(Sling Aircraft (Pty) Ltd. considers compliance with all Service Bulletins mandatory)

RELEASE DATE:	14/06/2024
EFFECTIVE DATE:	08/07/2024
SUBJECT:	Inspection and possible replacement instructions of the Sling 4 TSi seatbelt shoulder guide anchor bolts.
MODELS AFFECTED:	All Sling 4 TSi aircraft, up to (and including) SN 584.
COMPLIANCE TIME:	Next MPI (Mandatory Periodic Inspection) or annual inspection, whichever comes first.
LABOUR TIME:	45 minutes

Figure 4: Correct bolt installation.

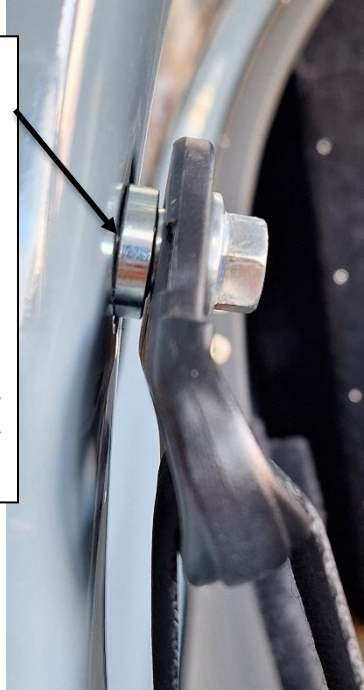
Step 2: Ensure the bolt and spacer are installed correctly, the spacer should fit flush with the composite canopy. The shoulder of the bolt presses up against the spacer (this can be seen in Figure 4 and when tightened compresses the spacer to the canopy). The correct installation can be seen in Figure 4, the incorrect installation can be seen in Figure 5. If the issues shown in Figure 5 are present in the installation, the bolt may not be screwed in all the way. **Do not** force the bolt into the hole, there may be debris on the nut's thread which need to be removed using a thread tap. This will be explained in Sections 3.3 and 3.4. It is also possible that the dog point of the bolt may be pressing up on the composite behind the nut. The bolts supplied with the service bulletin kits have this tip removed and will not cause interference.

The bolt is fully tightened such that the bottom of the shoulder sits against the spacer, and that the spacer sits flush with and compressed against the canopy inside skin.

Figure 6: Seatbelt shoulder bolt installation location

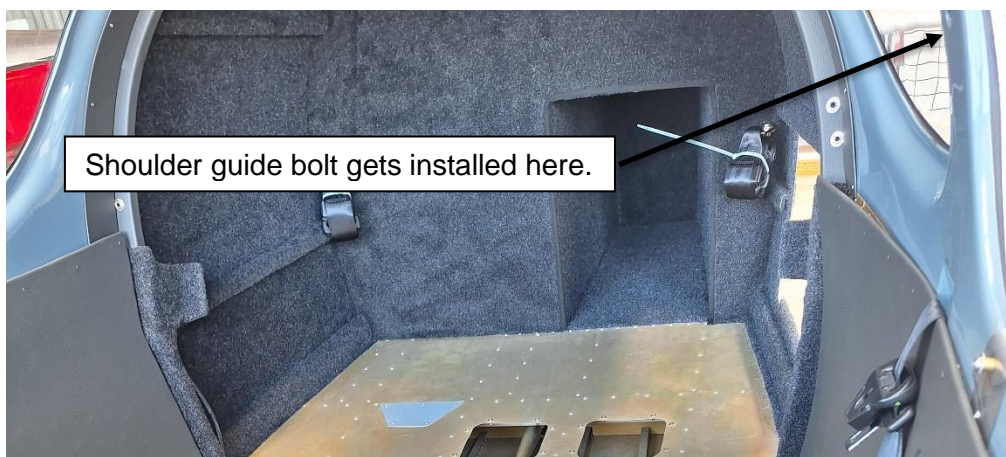
- Step 1: Due to the manufacturing process, there is a potential for contaminants to be present on the thread of the hole that the shoulder bolt of the seatbelt screws into. Due to this, the threads need to be inspected, and are to be free and clear of any debris (such as weld splatter, paint, resin etc.). These will be present on both the left- and right-hand side of the cockpit. Figure 6 shows the location of the hole on left side of the cockpit.

Figure 8: Shoulder bolt and spacer installation.

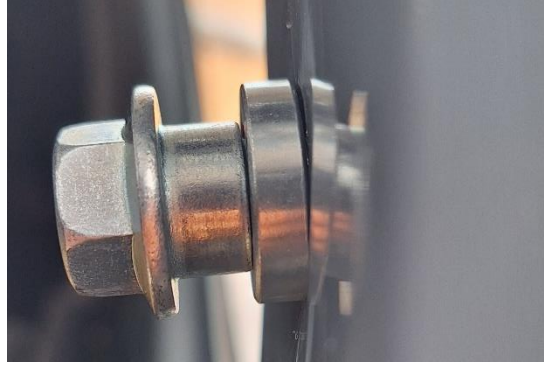
- Step 2: If there is debris present on the thread of the hole, an M11 tap must be used to clean the threads of the hole.
- Step 3: Once the holes have been tapped, the threads must be reinspected to ensure they are free of debris.
- Step 4: Once the holes are free of debris, install just the shoulder bolt and spacer as depicted in Figure 8.

Figure 10

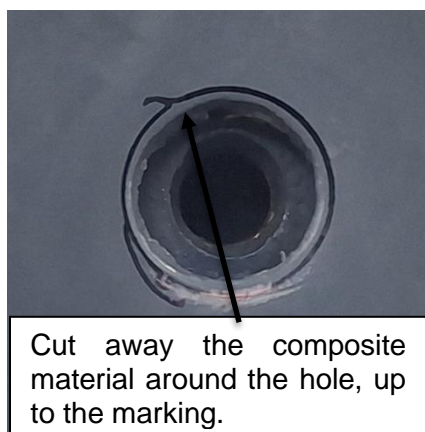
Step 6: Remove the bolt and spacer and use a Dremel or a file to sand away the composite up to the marking, that was made around the spacer. This hole should now be wide enough for the spacer to pass through the composite and sit flush on the mounting plate that is bonded into the canopy.

Figure 11: Seatbelt shoulder guide installation

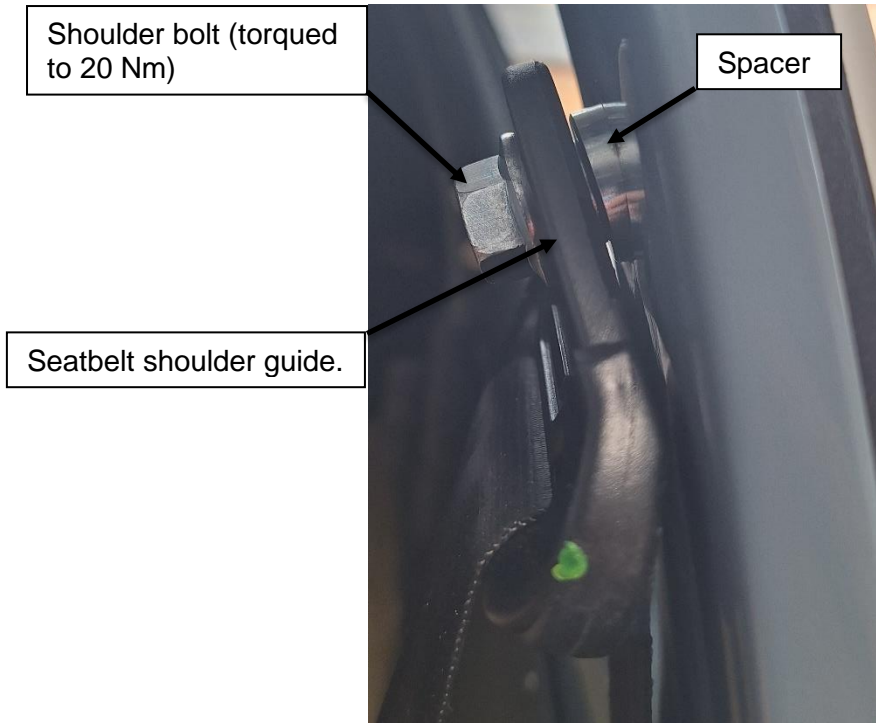
Step 7: Once the cutout has been widened, install the bolt, spacer and shoulder anchor guide of the seatbelt as seen in Figure 11. Ensure that the spacer fits through the cutout and is able to locate on the mounting plate that is bonded into the canopy. Loctite 243, or an equivalent, should be used on the bolt thread to ensure it does not unscrew on its own. Torque the bolt to 20 Nm.

Figure 13: Seatbelt shoulder bolt installation location

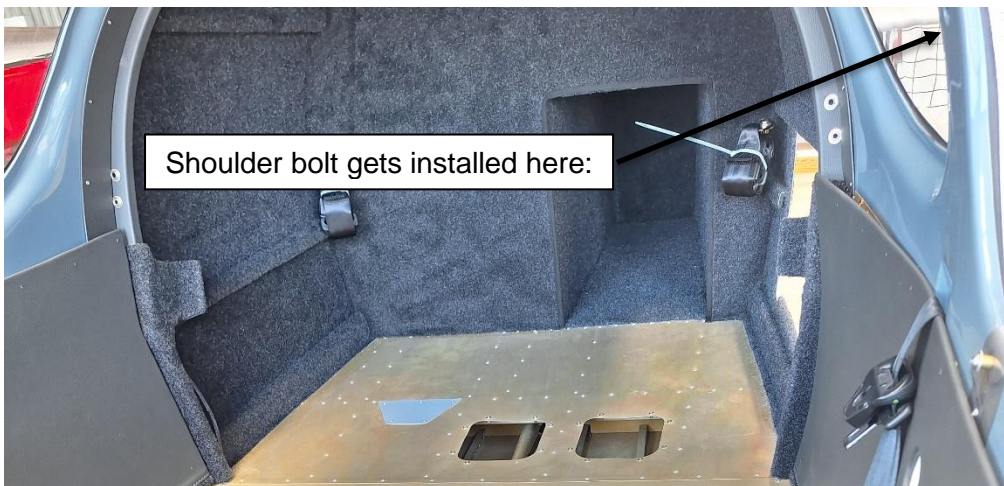
- Step 1: Due to the manufacturing process, there is a potential for contaminants to be present on the thread of the hole that the shoulder bolt of the seatbelt screws into. Due to this, the threads need to be inspected, and are to be free and clear of any debris (such as weld splatter, paint, resin etc.). These will be present on both the left- and right-hand side of the cockpit. Figure 13 shows the location of the hole on left side of the cockpit.

Figure 15: Seatbelt shoulder guide installation

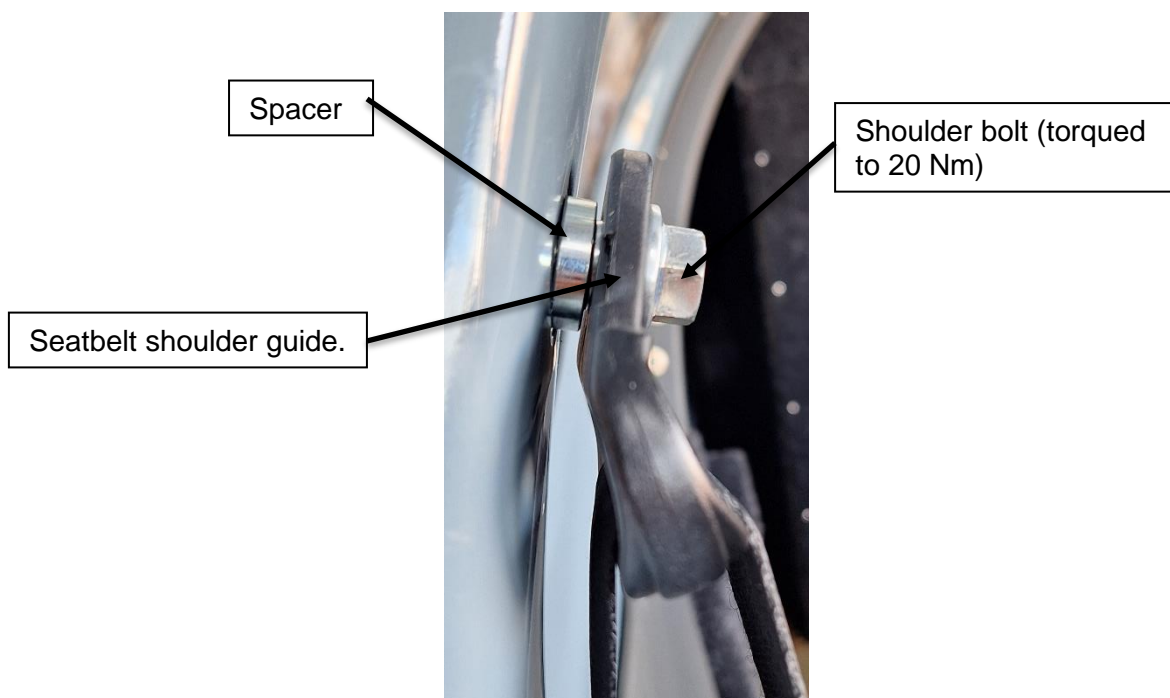
Step 4: Install the bolt, spacer and shoulder anchor guide of the seatbelt as seen in Figure 15. Loctite 243, or an equivalent, should be used on the bolt thread to ensure it does not unscrew on its own. Torque the bolt to 20 Nm.
